Village of Arlington Heights
Plan Commission
Board Room
Arlington Heights Village Hall
33 S. Arlington Heights Road
Arlington Heights, IL 60005
July 11, 2018
7:30 PM

- A. European Crystal Hotel - 519 W. Algonquin Rd. - PC#18-013
Land Use Variation for Hotel, Variation from Chapter 28 of the
Municipal Code

Project Number: PC 18-013
Project Title: European Crystal Hotel
Address: 519 W. Algonquin Rd.
PIN: 08-16-103-008, 08-16-103-009

1 PROPOSED FIRST FLOOR PLAN
SCALE : 3/32" = 1'-0" MAY 4, 2018

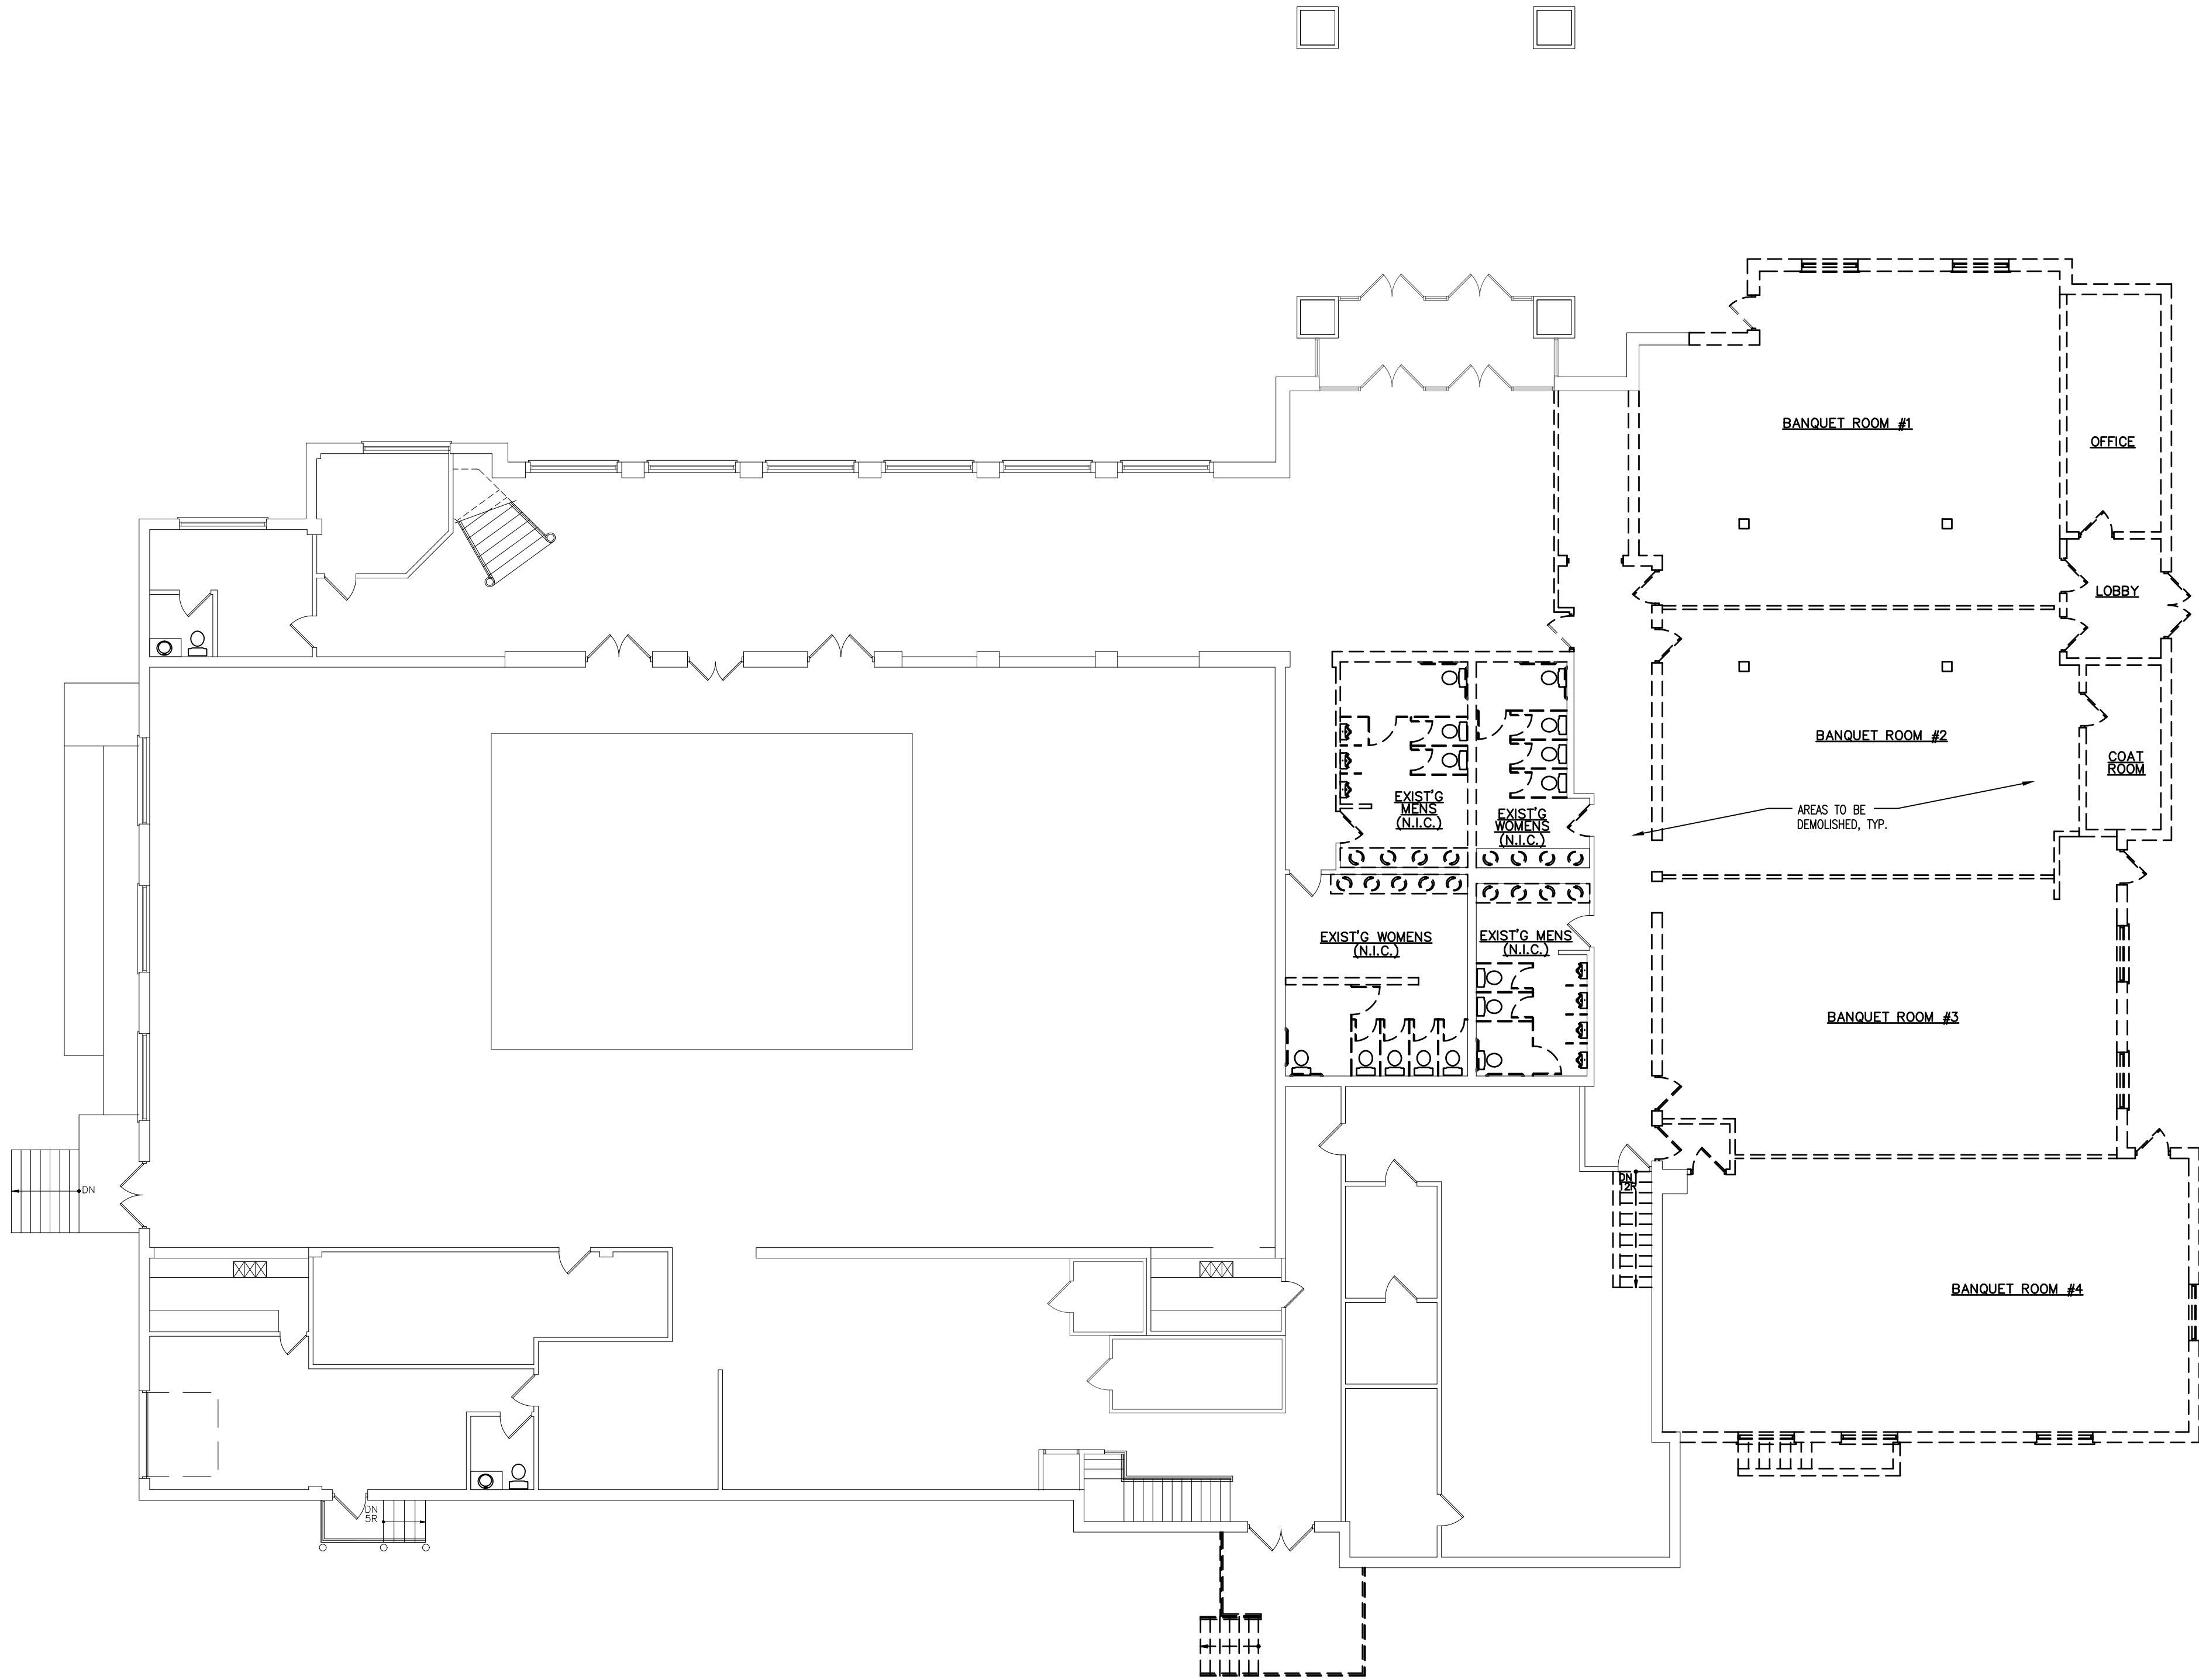
Sheet 1 Proposed First Floor Plan:

1. Women's Restroom: In restrooms with six or more toilet stalls in addition to the standard stall configuration for wheelchair accessibility complying with subsection (n)(5)(A) (ii), IAC Section 400.310(n)(5) requires the addition of a 36-inch wide toilet stall where the doors open out and is equipped with parallel grabs on each side of the stall per IAC 400. Illustration B. Figure 30(d) and q. Pictured below.

2. The "Single User Restroom shall comply with IAC Section 400.310(n)(9-11).

3. Coffee Vending Room: Please see IAC Section 400.320(l)(6 and 8) and 400.Illustration B., Figure 54.

Figure 6

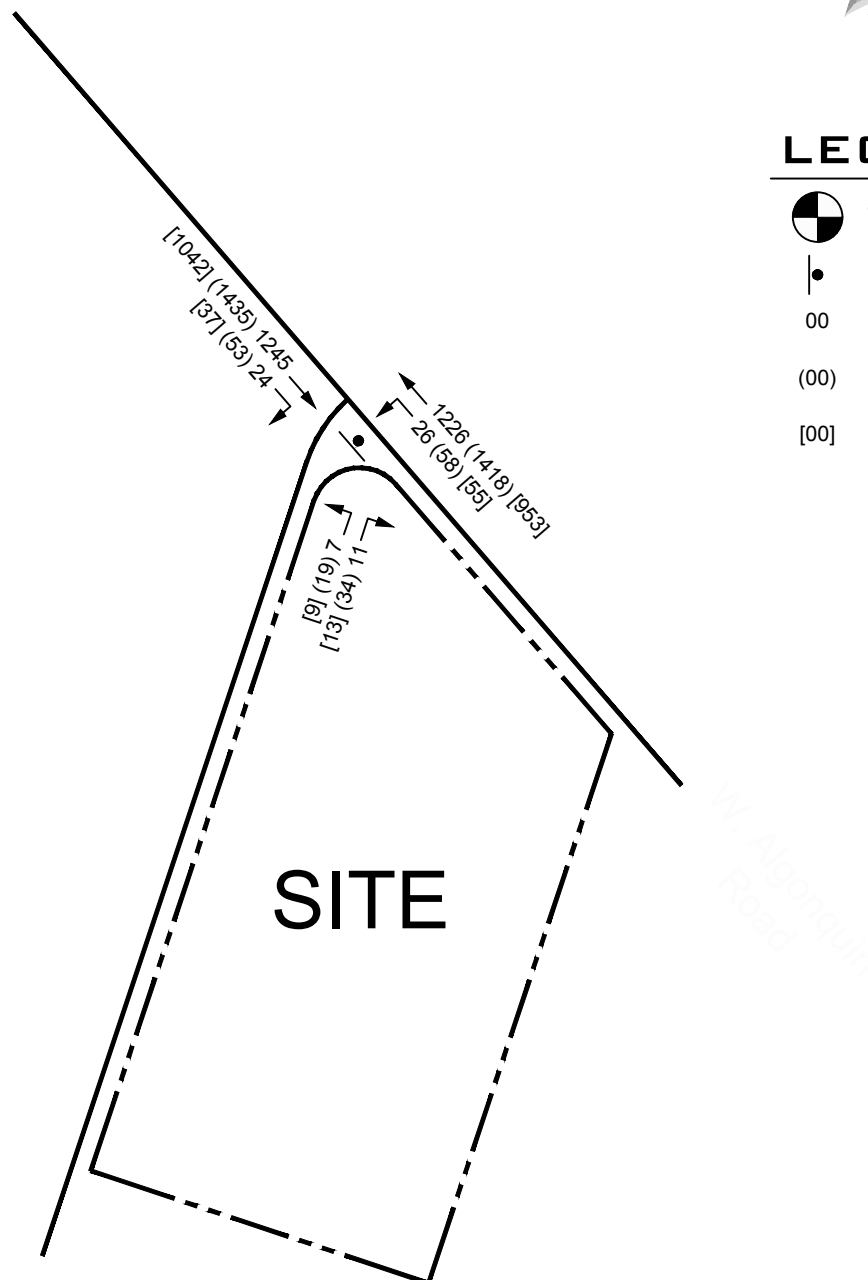
- 19 Q In Title of Figure 6, indicates 'Additional' Banquet Traffic Assignment, but the values from Table 2 include both the Existing Volumes and Additional Traffic total. Wouldn't Existing Volumes be included in the Existing Traffic Volume Counts?

- A **The additional volumes included in Figure 6 is the net additional traffic beyond the existing banquet traffic volumes included in the existing traffic counts. The existing volumes were included in Table 2 for reference but not shown on Figure 6 since they are part of Figure 3.**
